ADDENDUM 1

PROJECT NAME: Churchill Ave Area Drainage Improvements

DATE: 11/01/2023

PROJECT NO: 23-03797

SHEET 29 OF 56

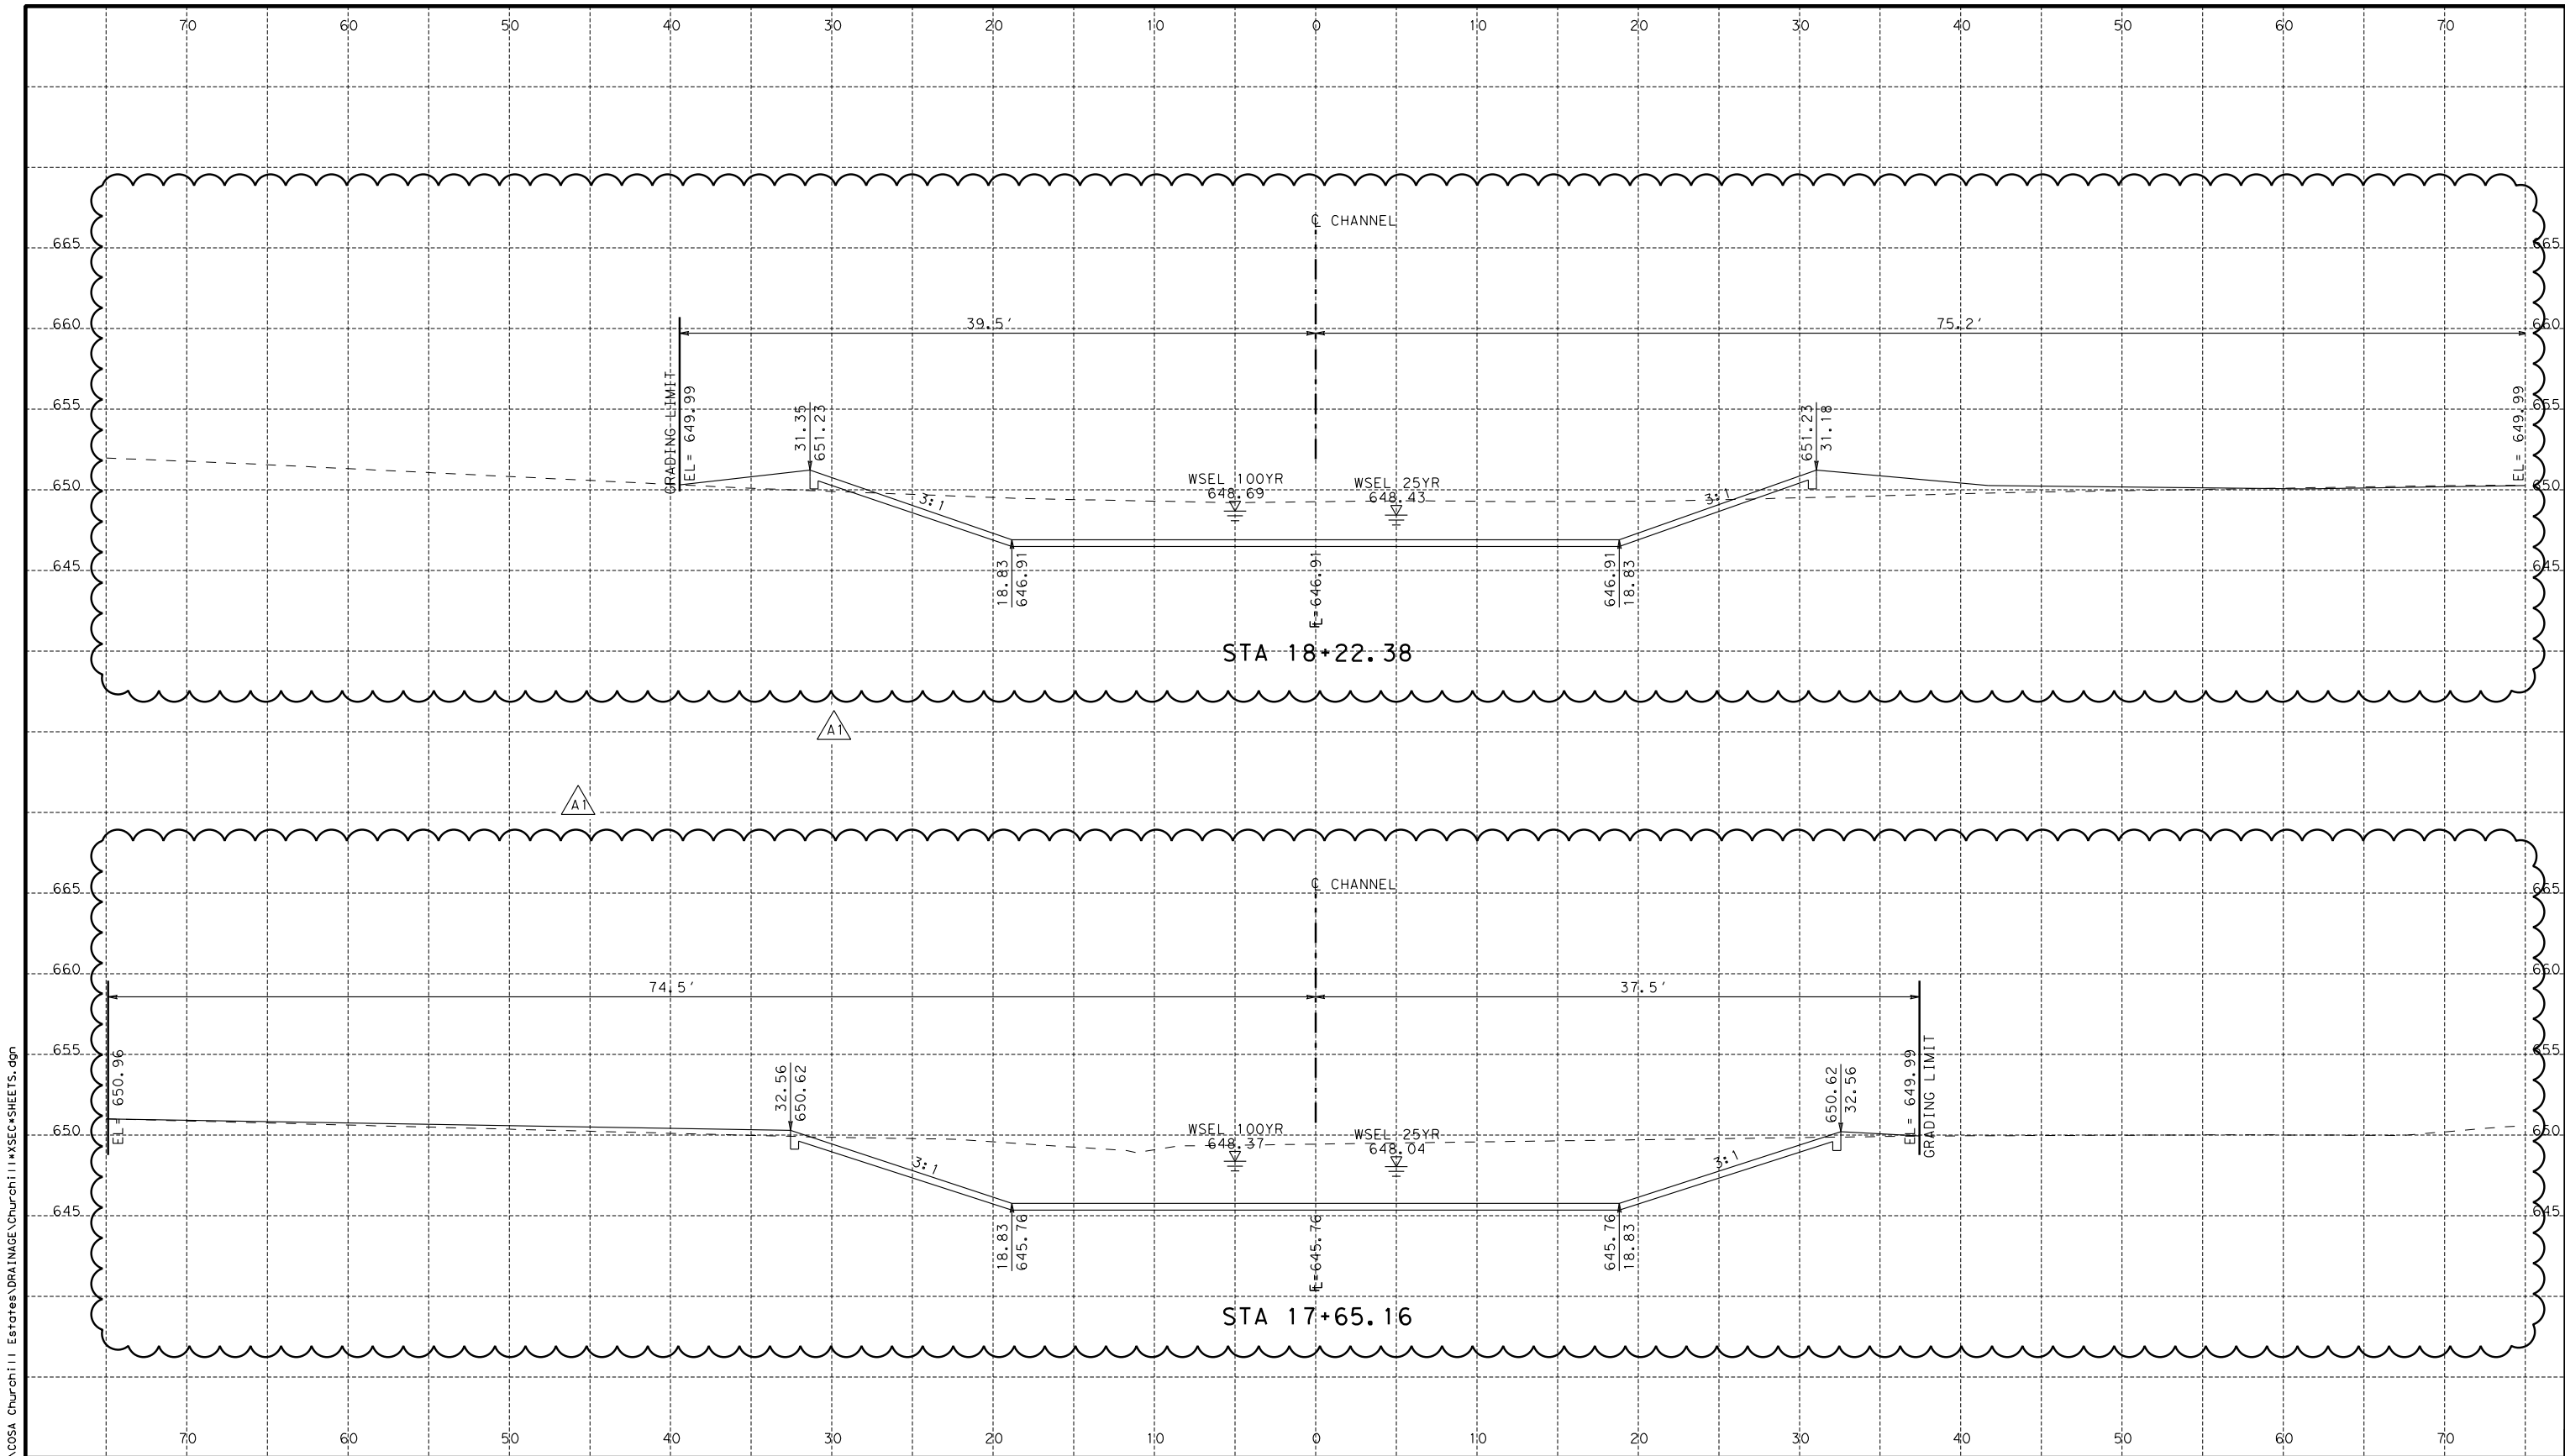
1. Revised Plan Sheet 79 – Cross Sections – Revised grading and riprap tie in elevations callouts to match details.
2. Revised Plan Sheet 96 – Cross Sections – Revised grading and riprap tie in elevations callouts to match details.
3. Revised Plan Sheet 97 – Cross Sections – Revised grading and riprap tie in elevations callouts to match details.
4. Revised Plan Sheet 98 – Cross Sections – Revised grading and riprap tie in elevations callouts to match details.
5. Revised Plan Sheet 112 – Drainage Details – Updated riprap elevation.

2. Question: Cross section @ station 18+22.38, grading elevation at right side does not match at end of grading limits. Please clarify.

Response: Cross section plan sheet 79 has been updated to reflect the correct tie in elevations to match the riprap details and grading layouts.

REVISIONS		
DATE	NO.	DESCRIPTION
OCT '23	A1	REVISED TIE-IN ELEVATIONS

SHEET 46 OF 56

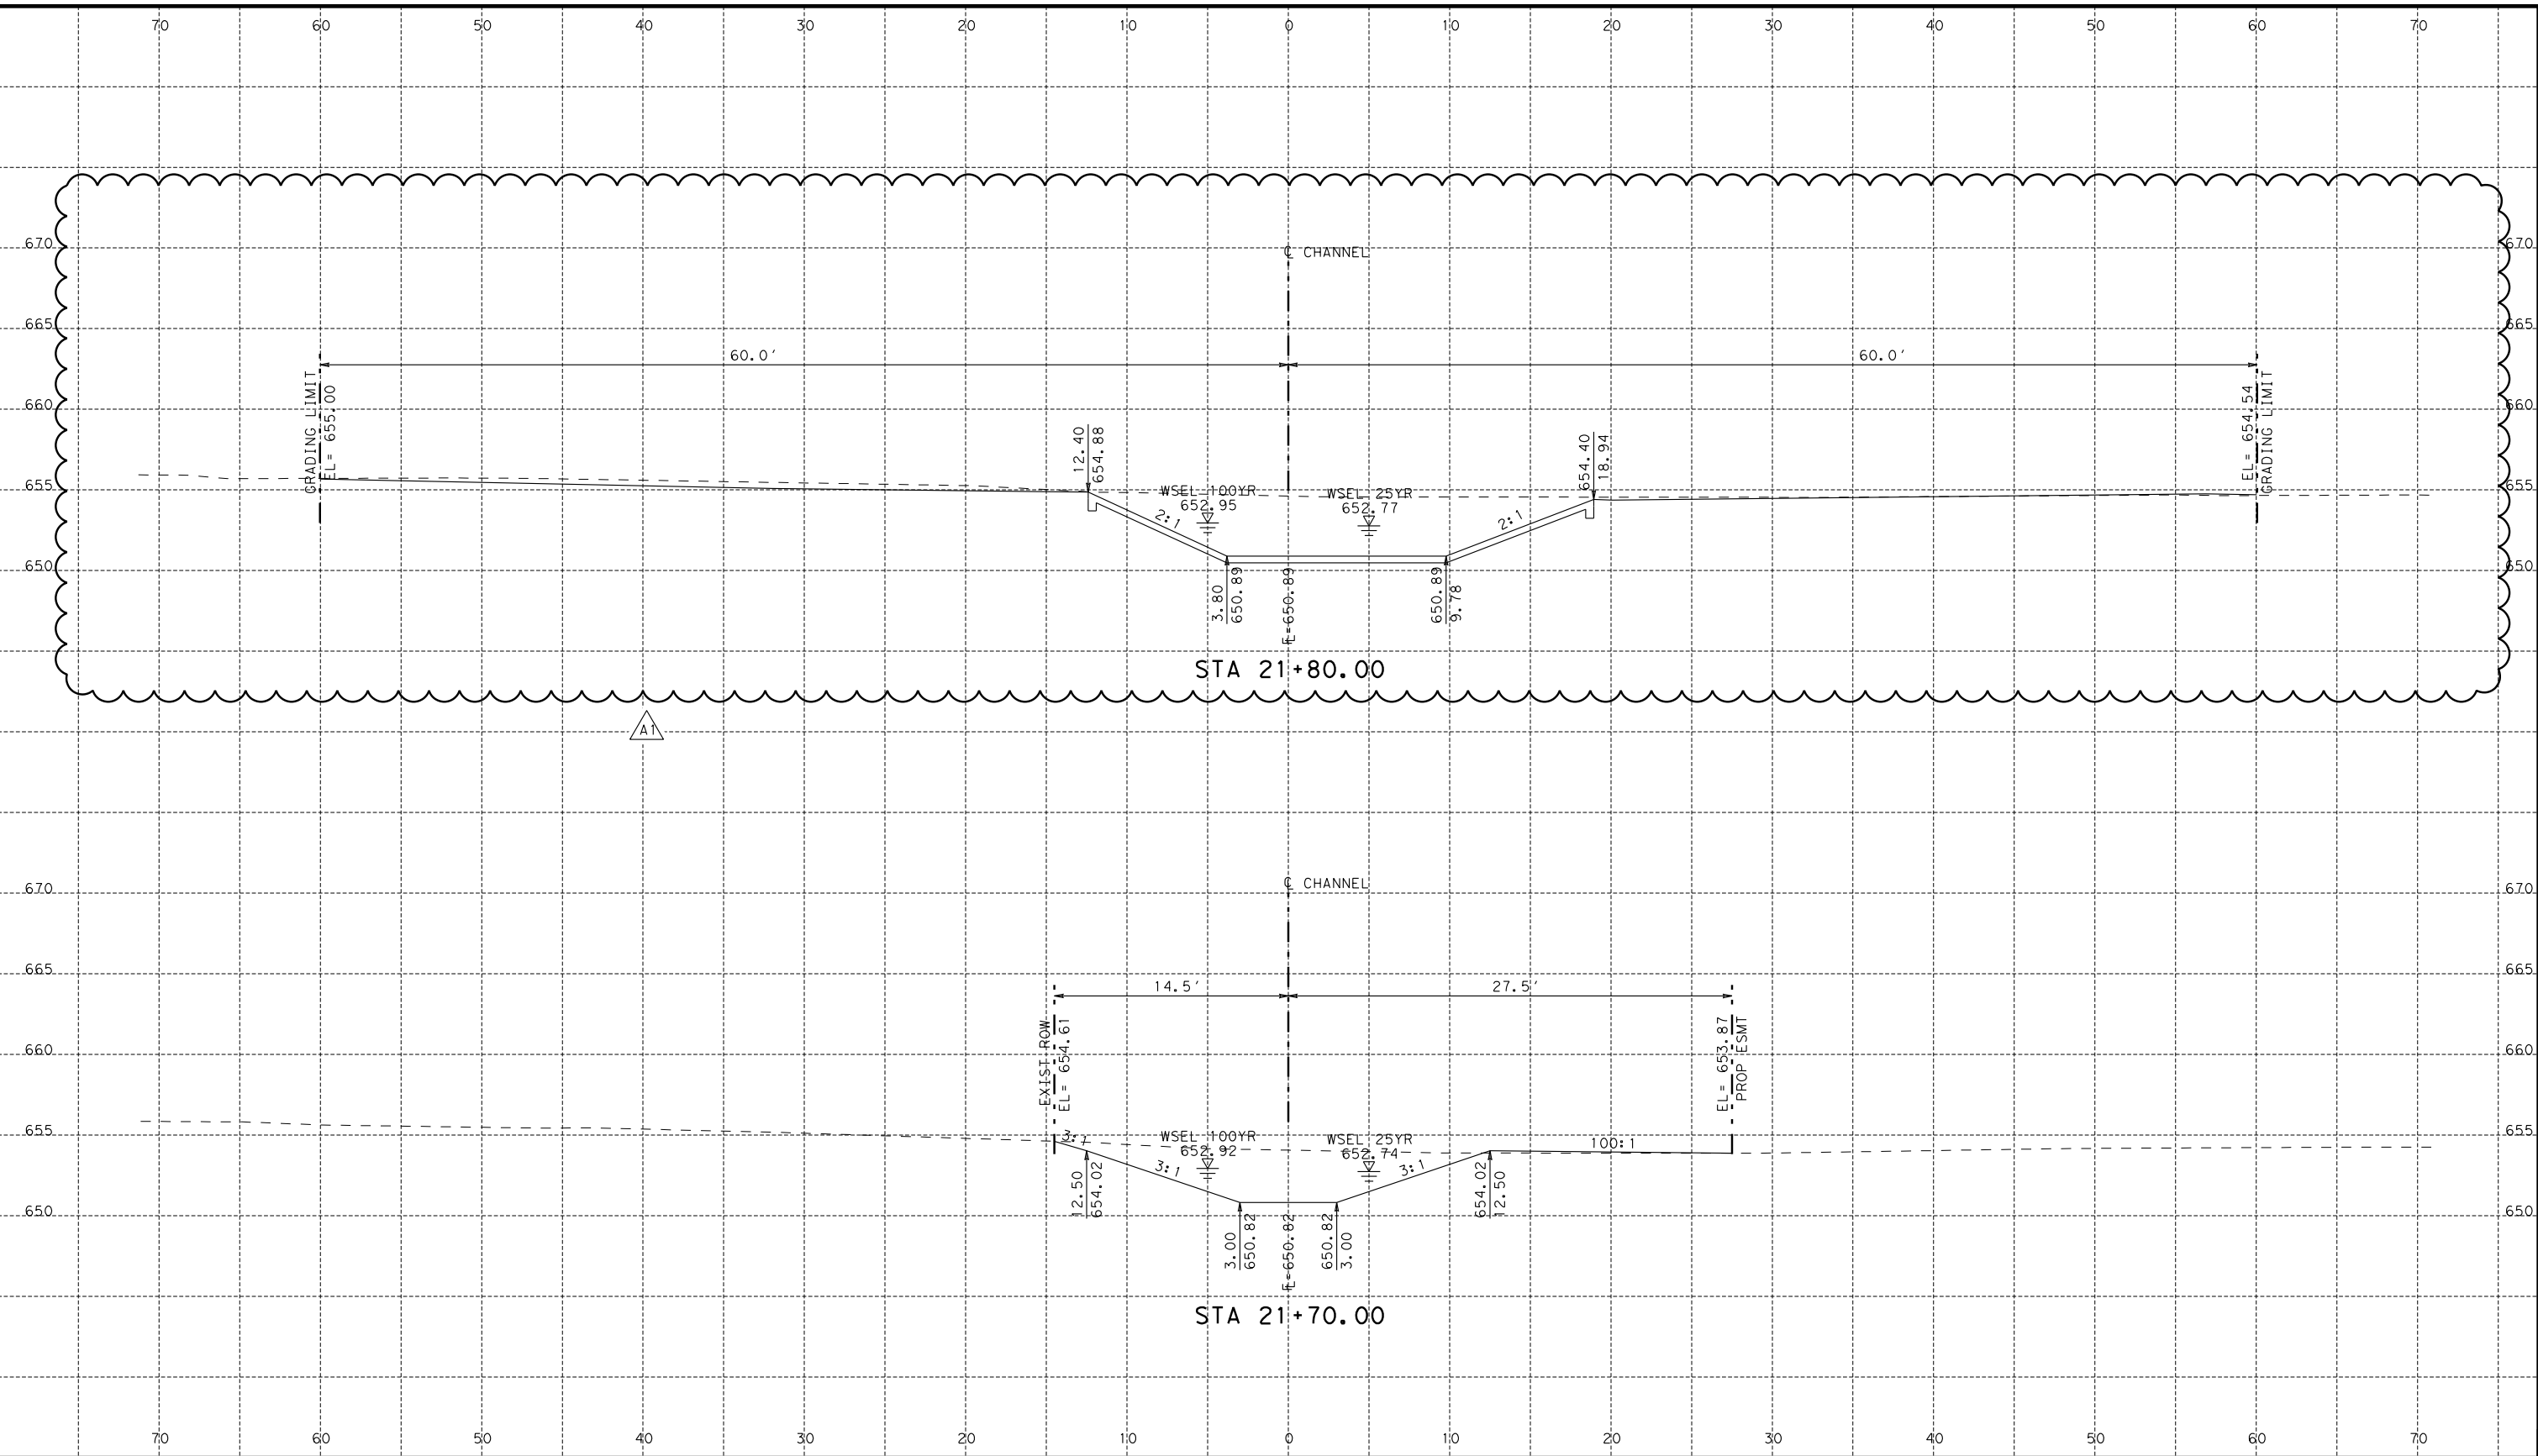
3. Question: Cross sections @ station 21+80.00 to 22.21.98 grading elevation at left side does not match at end of ROW. Please clarify.

Response: Cross section plan sheets 96-98 have been updated to reflect the correct tie in elevations to match the riprap details and grading layouts.

REVISIONS		
DATE	NO.	DESCRIPTION
OCT '23	A1	REVISED TIE-IN ELEVATIONS
